### STAFF REPORT FOR THE PLANNING COMMISSION

FILE NUMBER:	SUB-18-04/WAP-18-05
HEARING DATE:	August 21, 2019
REQUEST:	12-lot Subdivision at 22870 Weatherhill Road
APPROVAL CRITERIA:	Community Development Code (CDC) Chapter 12, Single-Family Residential Detached and Attached, R-7; Chapter 32, Water Resource Area Protection; Chapter 48, Access, Egress and Circulation; Chapter 55, Design Review; Chapter 85 Land Division General Provisions; Chapter 92, Required Improvements.
STAFF REPORT PREPARED BY:	Jennifer Arnold, Associate Planner

# ADDENDUM PLANNING COMMISSION STAFF REPORT August 21, 2019

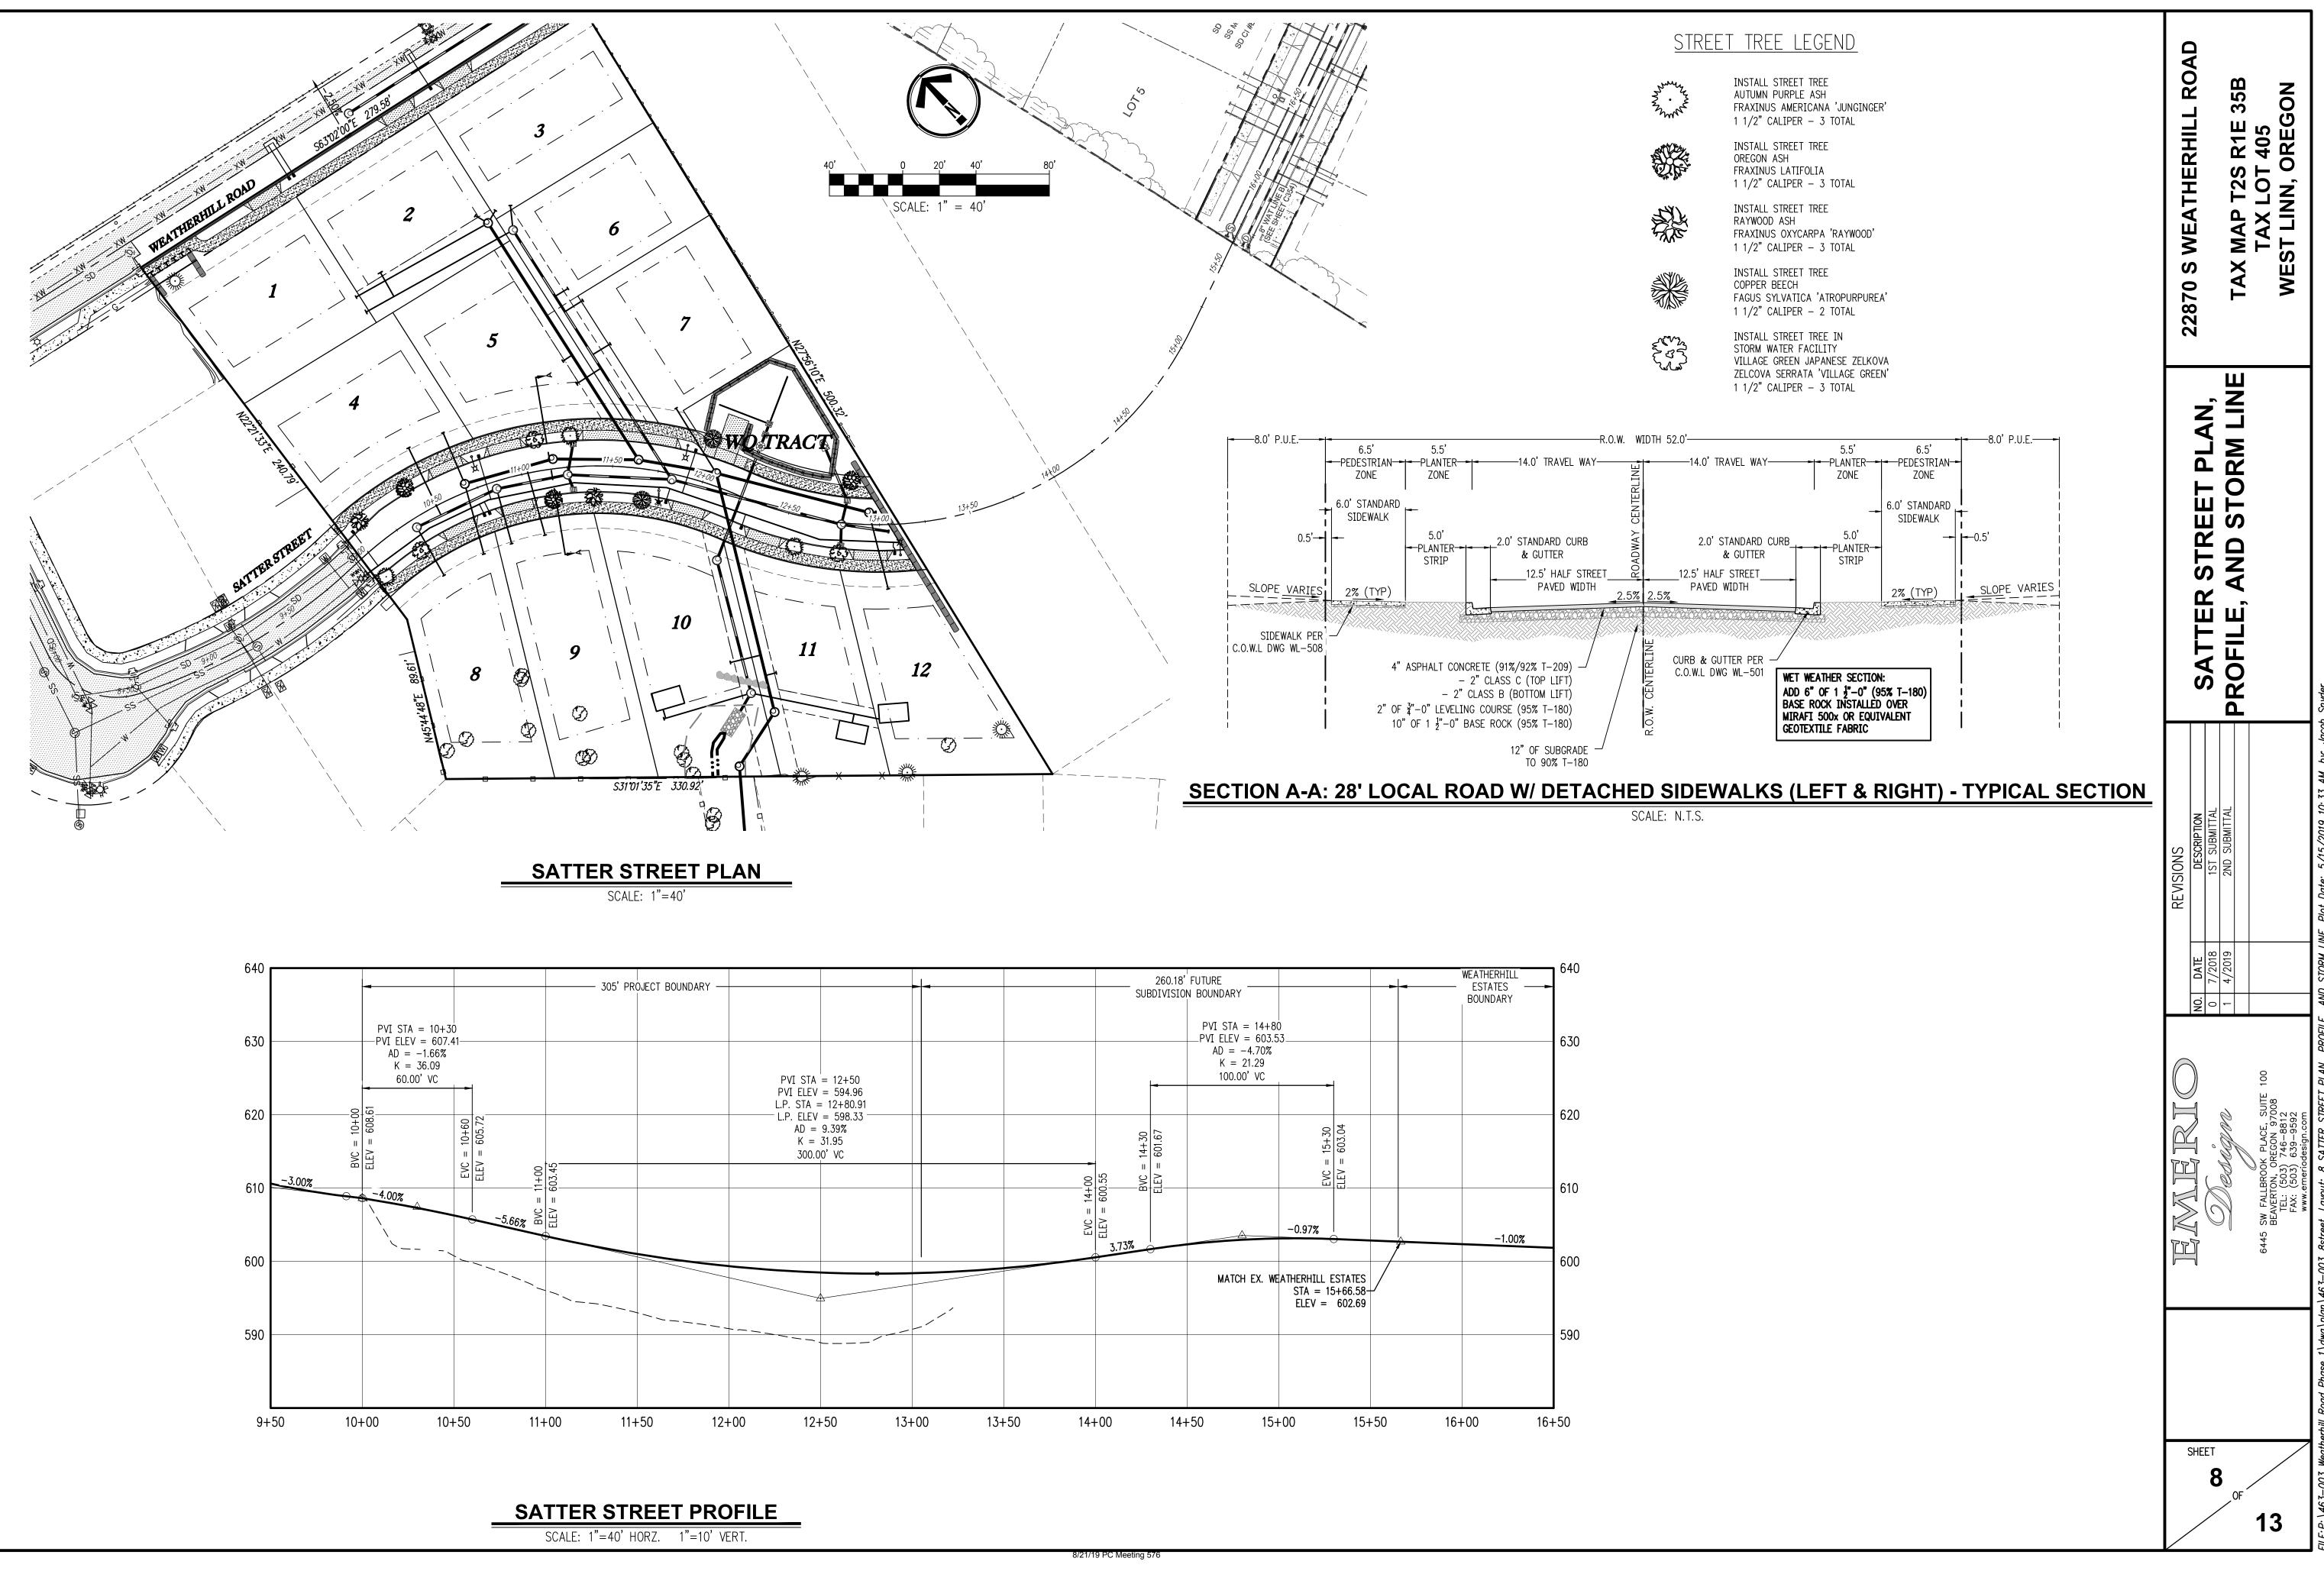
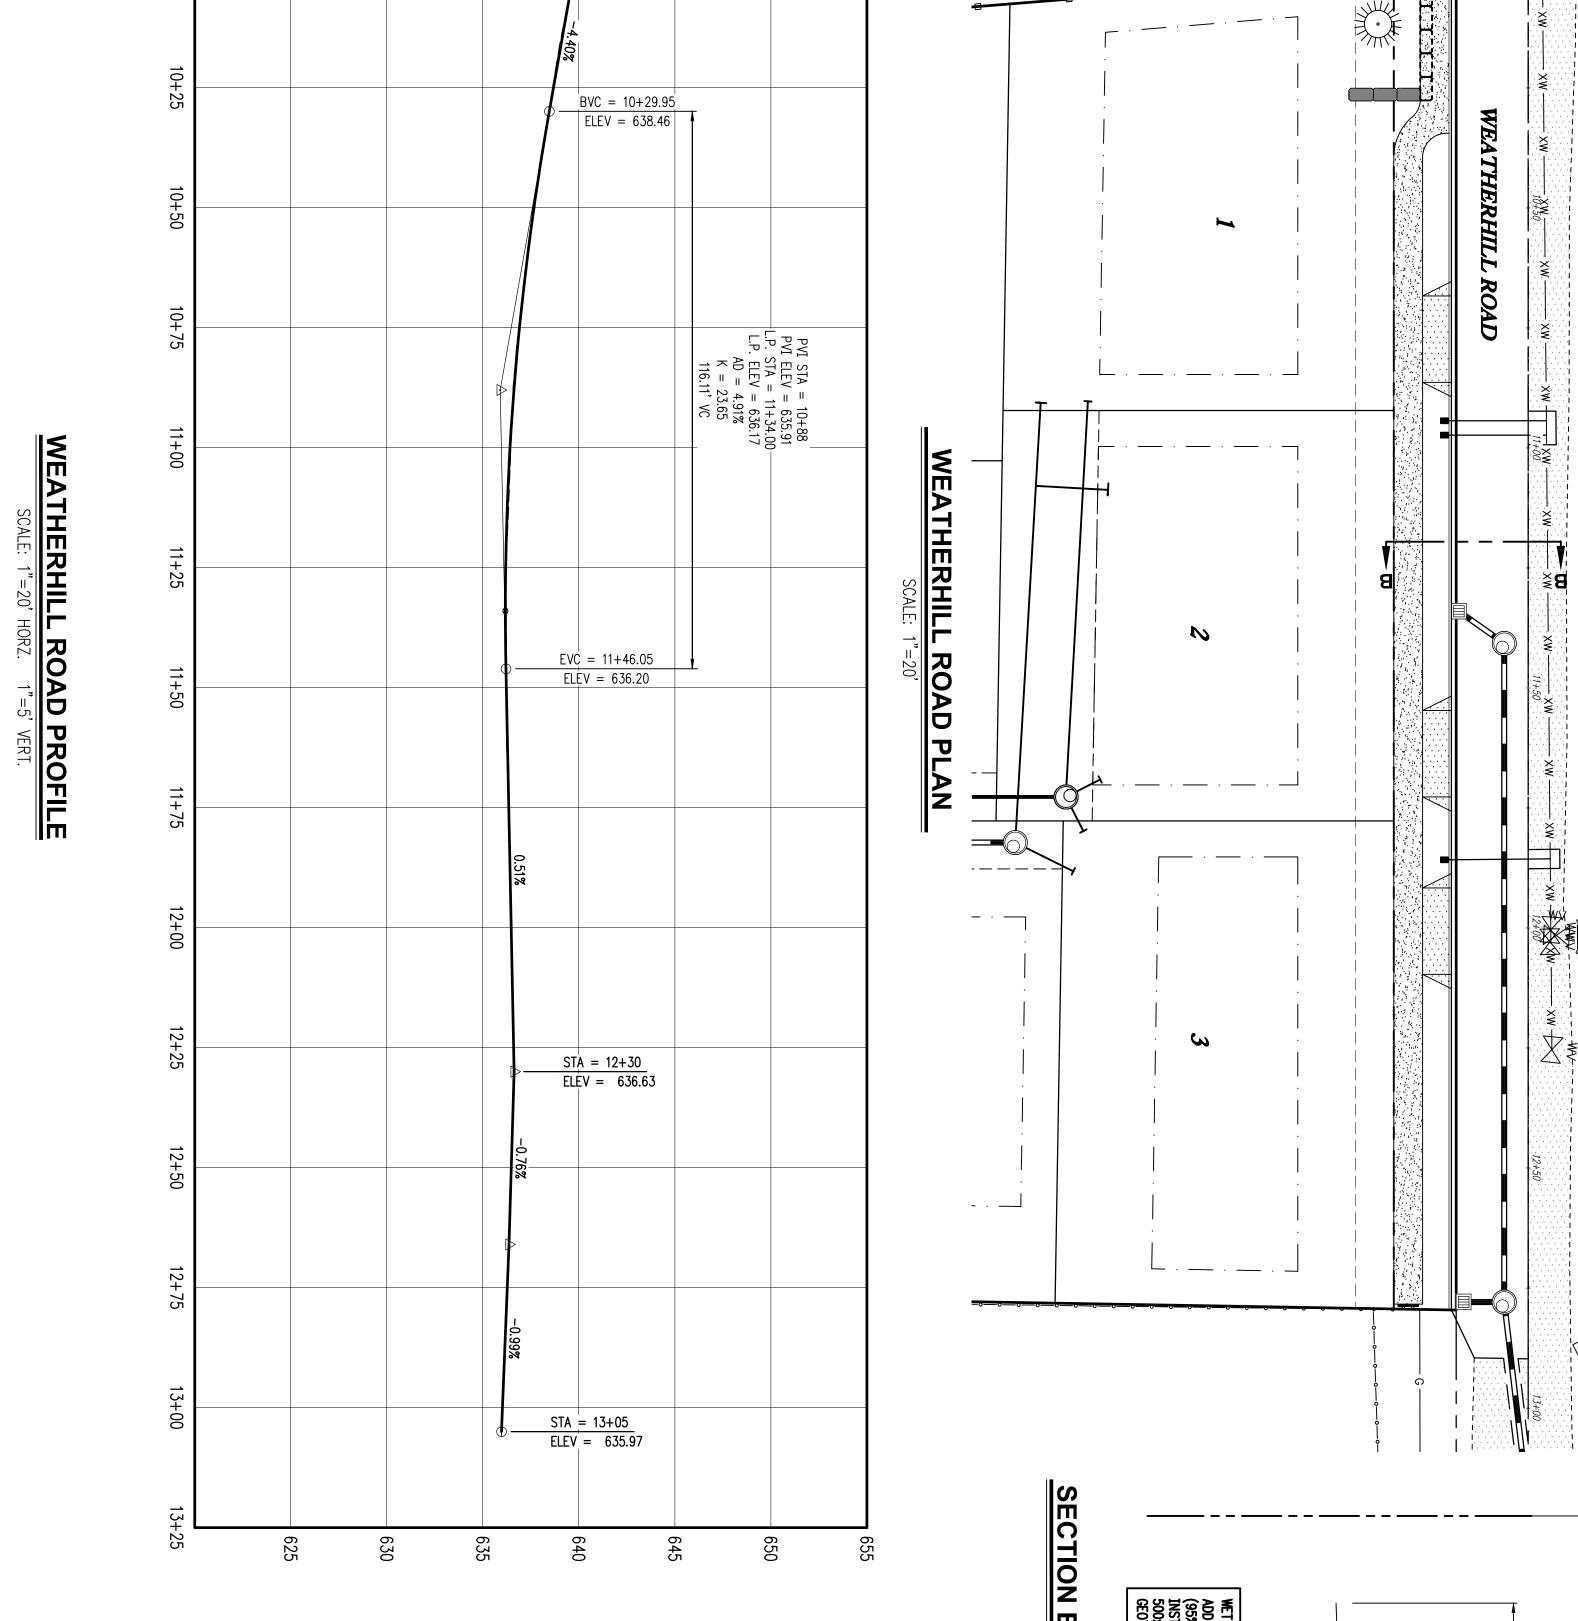
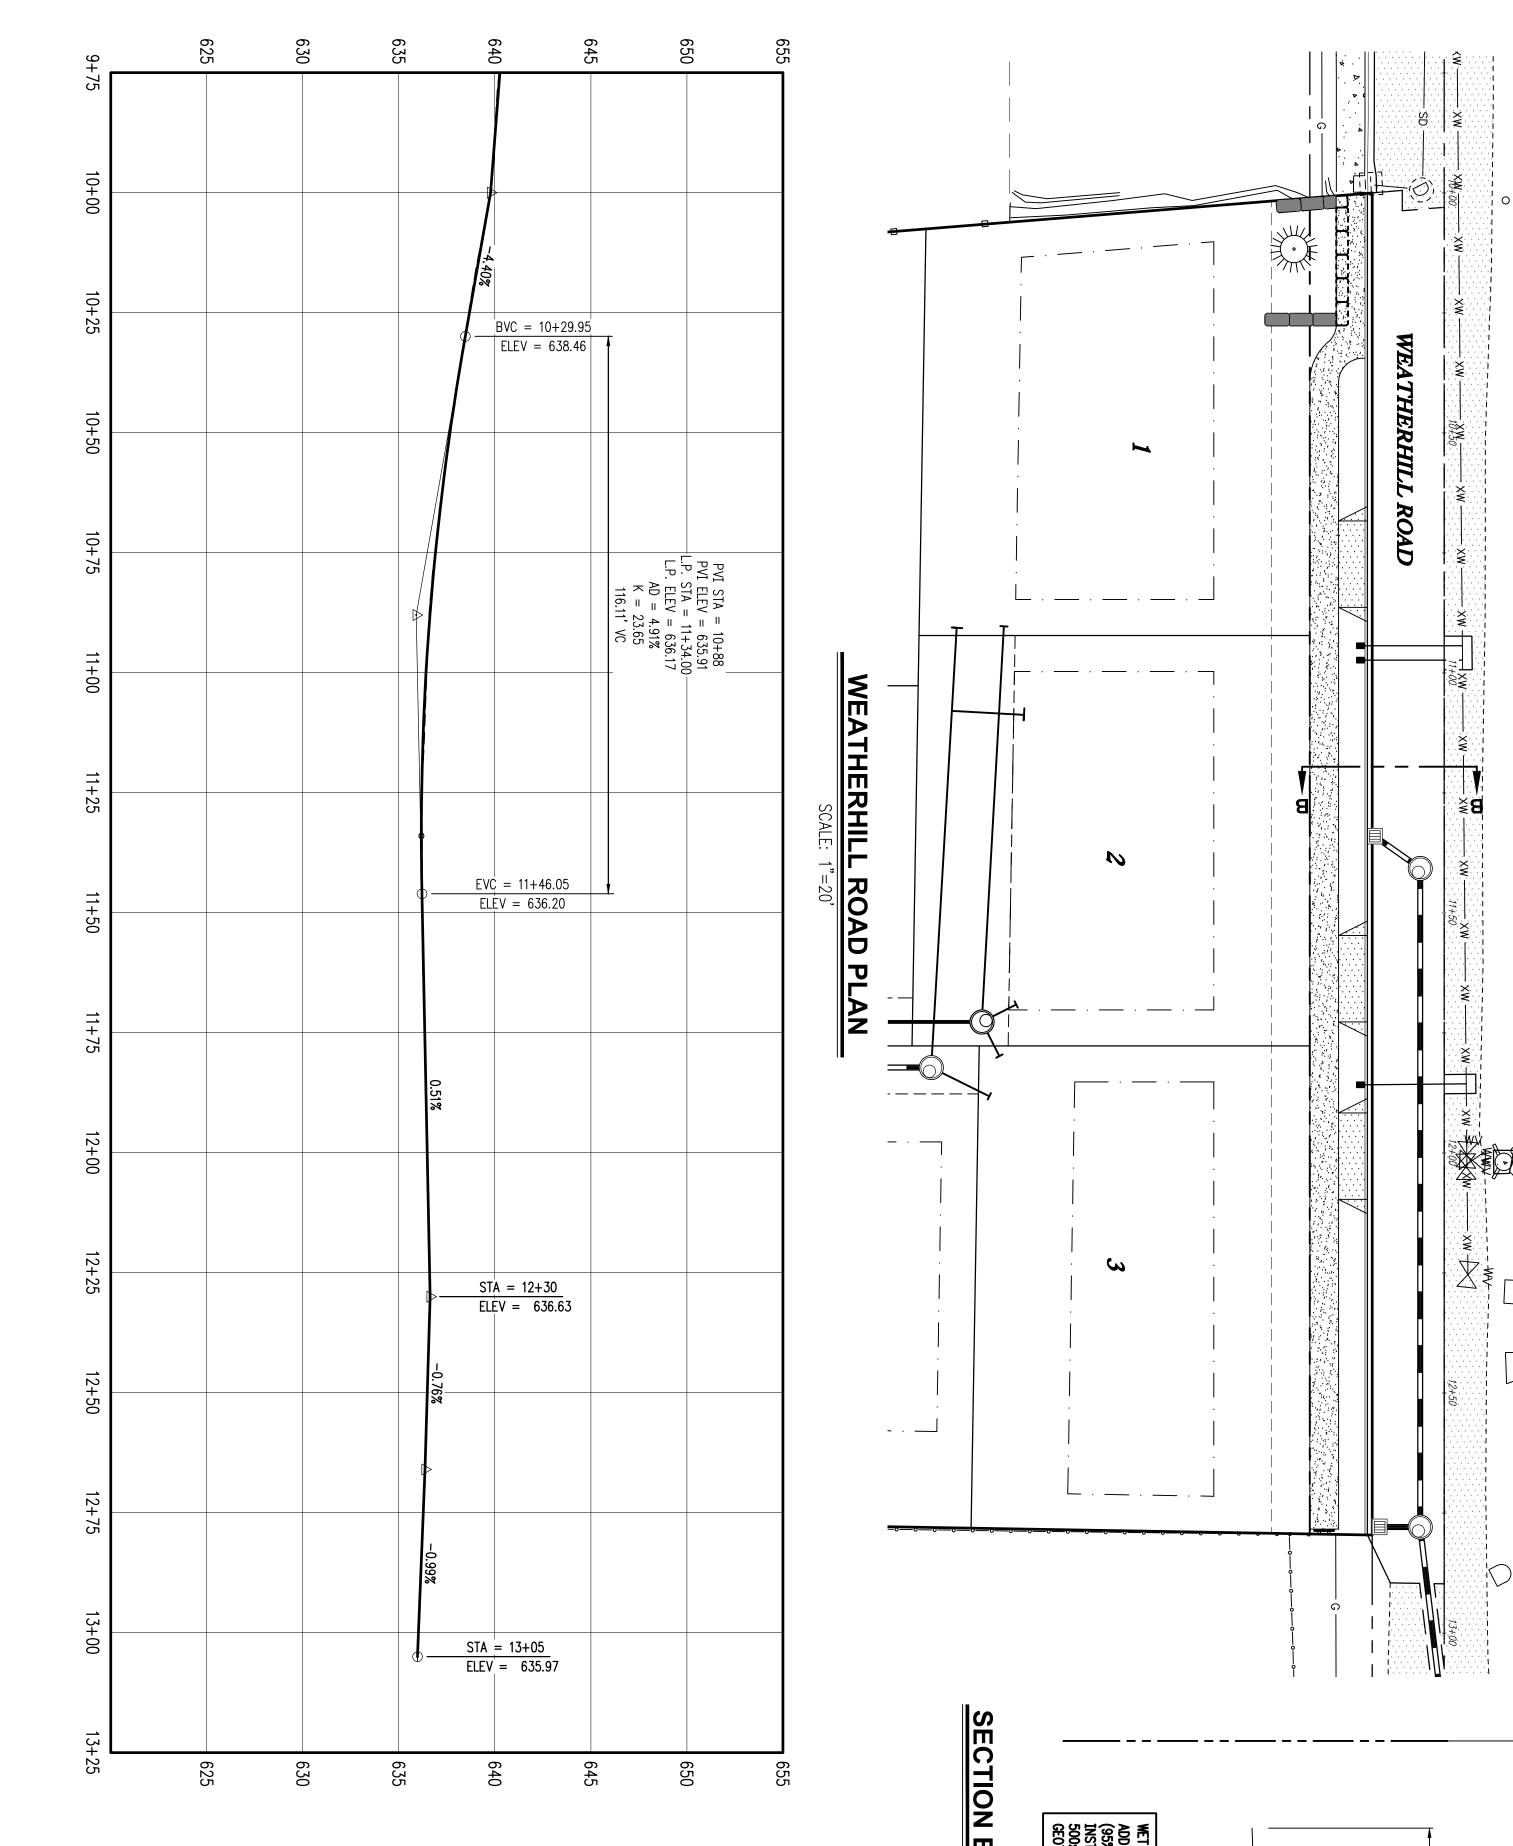
Staff Finding 17: The applicant proposes to provide access to Weatherhill Road (lots 1, 2, and 3) and Satter Street (lots 4-12). The applicant shows a shared curb cut for lots 6 and 7 on sheet 7/13. Proposed lot 6 is a flag lot with 19.8 feet of street frontage on Satter Street. This criterion is met.
